RE: Preliminary Adequacy Response; M-2004-044

This letter serves as the Preliminary Adequacy Response for the 112c Construction Materials Amendment Application (AM-2), Permit No. M-2004-044. The Preliminary Adequacy Review was summarized in your letter of November 17, 2021. The italicized items are the current comment and the bold text are the responses:

TUCSON SOUTH RESOURCE
PRE-MINING AND MINING PLAN MAPS

DRAWN BY: CI DATE: AUGUST 21
CHECKED BY: GL SCALE: AS NOTED
AS NOTED
JOB NO.: 297.001.09
DWG NAME: C7.dwg

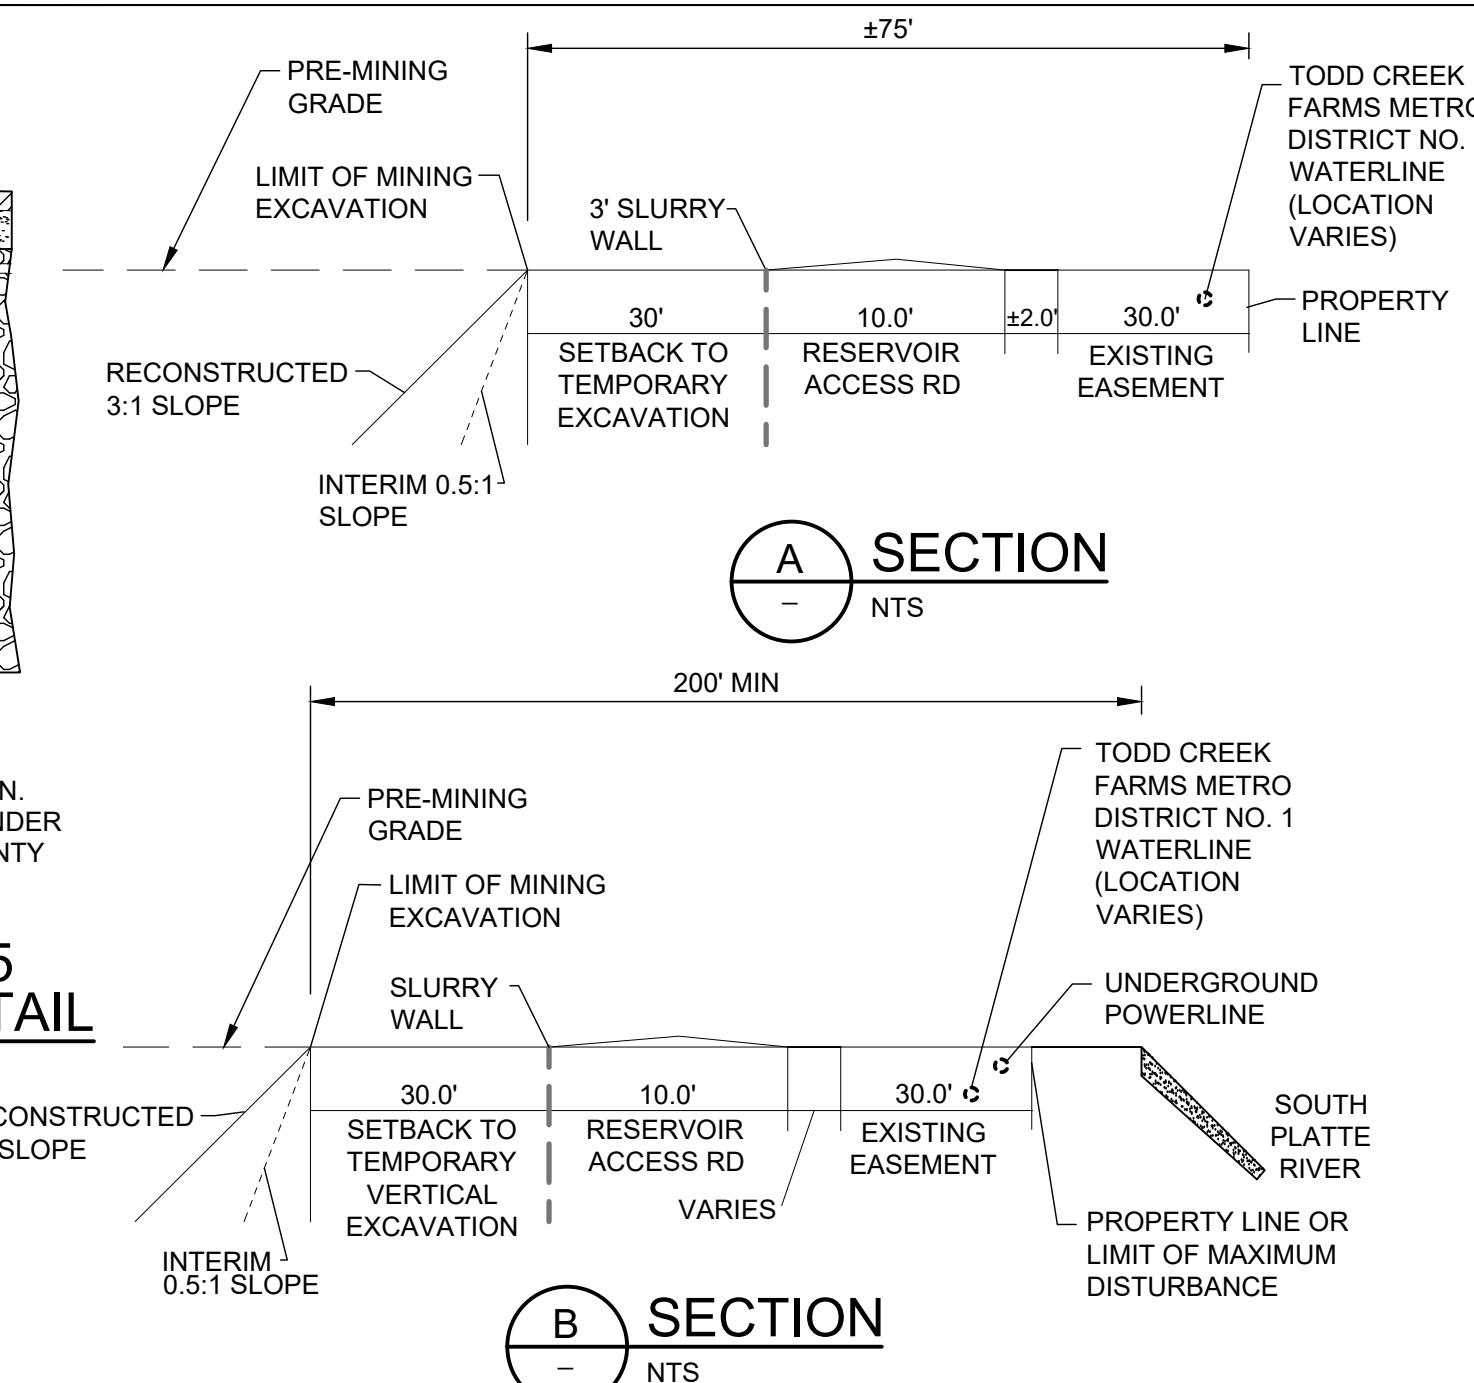
- 14.** *Please provide a typical cross section for the overhead conveyor crossing and include on map C-8.*

The typical cross section has been added to Sheet C-8. Please see the attached Exhibit C.
